JOINT REGIONAL PLANNING PANEL (Sydney East Region)

JRPP No	2013SYE057
DA Number	LDA 2013/0260
Local Government Area	City of Ryde
Proposed Development	Demolition of all existing buildings and structures and the construction of a residential flat building comprising 5 buildings accommodating 179 dwellings over basement parking for 216 vehicles
Street Address	1-9 Allengrove Crescent, North Ryde 116A-122B Epping Road, North Ryde 259-263 Lane Cove Road, North Ryde
Applicant/Owner	Gordon Five Pty Ltd, c/- SJB Planning
Number of Submissions	1
Recommendation	Approval with Conditions
Report by	Brad Roeleven - City Plan Strategy & Development on behalf of City of Ryde

Assessment Report and Recommendation

Figure 5: Nos. 253-257 Lane Cove Road, North Ryde

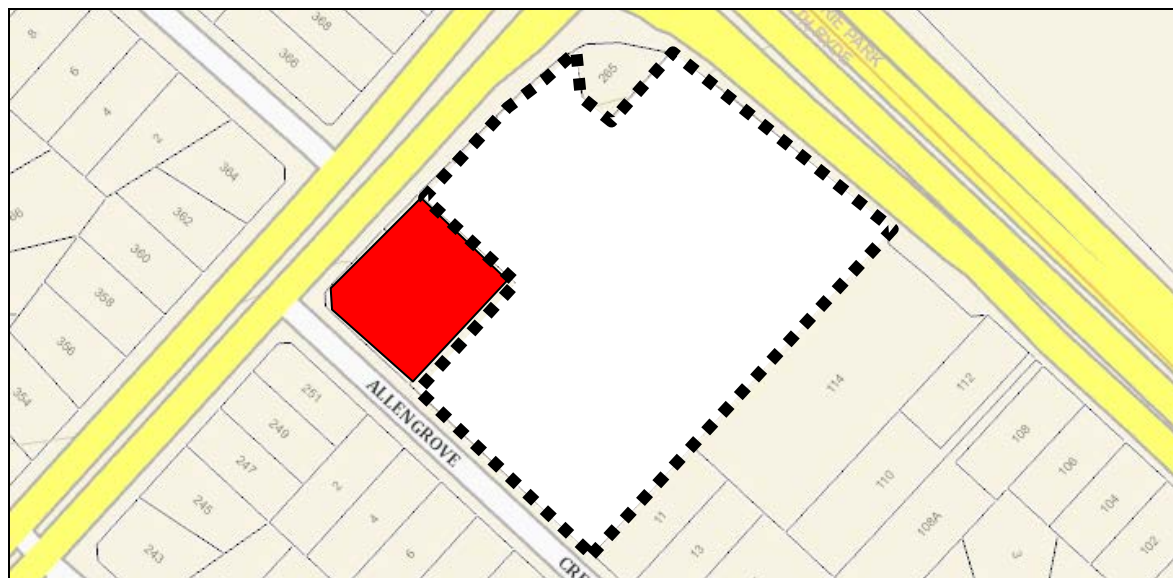
The development site excludes No. 253-257 Lane Cove Road, North Ryde (being Lots 1 and 2 DP 656172) as shown in red at Figure 5 below. That land has an area of about 1,660m².

In its assessment of MP10_0037 the Department of Planning and Infrastructure found:

- The proponent had properly demonstrated unsuccessful attempts to amalgamate that land with subject site; and
- The future development of No. 253-257 Lane Cove Road, North Ryde would not be prejudiced.

It is noted that under Ryde LEP 2010 and DCP 2013 the relevant controls for multi unit dwellings in the R2 Low Density zone are:

- Density control of 300m² (1,2 or 3 bedroom dwelling) and 365m² for a 4 bedroom dwelling (LEP); and
- Minimum lot size of 600m² and street frontage of 20m (DCP).

It is therefore agreed that the capacity for redevelopment of Nos. 253-257 Lane Cove Road, North Ryde is not prejudiced by this proposal.
